##### H.1.c.e 944 Heywood Avenue - Update Report: Development Permit with Variances Application No. 00003 (Fairfield)

**Subject:** **Update Report: Development Permit with Variances Application No. 00003 for 944 Heywood Avenue**

Proposed Small Lot Subdivision - 944 Heywood Avenue

Photo 3. South east corner of yard showing multi-stemmed tree #11) Douglas Maple on left and tree #10) European ash on right.

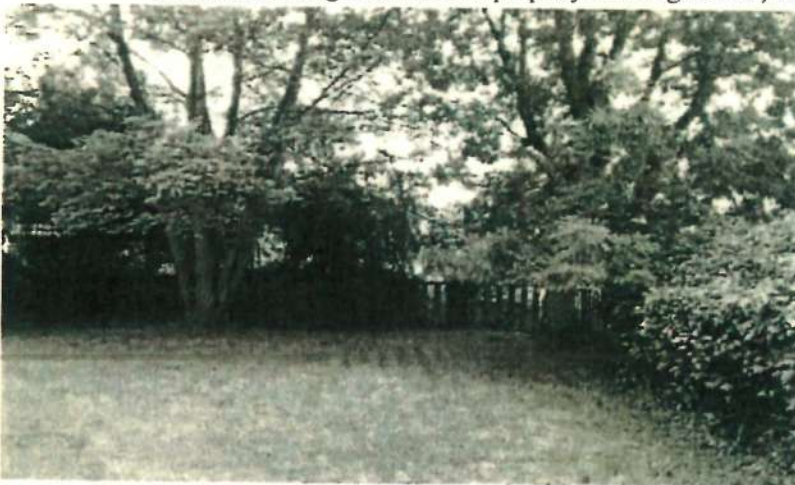
Building footprint. Severing a root this size and in this close proximity (2.7m) to the stem will destabilize the tree and likely cause significant stress resulting in premature mortality.
